CHANGE NOTIFICATION

PCN# 042513

Subject: Notification of Assembly Process change for LTM8029 and LTM8032

LTM8029- Current and New DESIGN

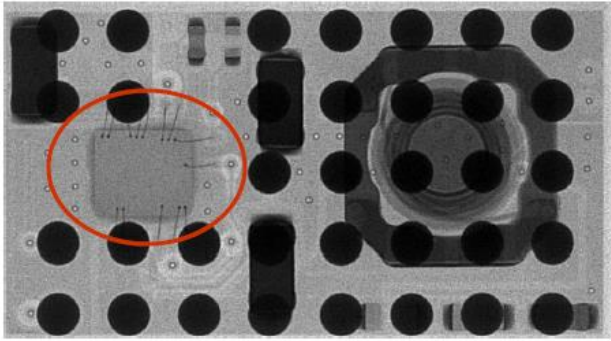
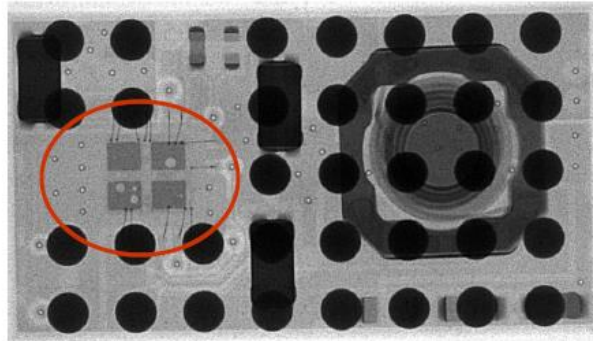
Please be advised that Linear Technology Corporation has made a minor change to the internal package construction to facilitate the use of one attach material for both die and components. The die attach material is changed from epoxy to solder, which is already used for attaching components in the same μ Module device package. In order to use the solder die attach, the die attach paddle (DAP) has been modified by splitting the DAP into multiple pads for dice D1 and U1. Linear has been shipping several μ Module devices using solder for die attach and component attach.
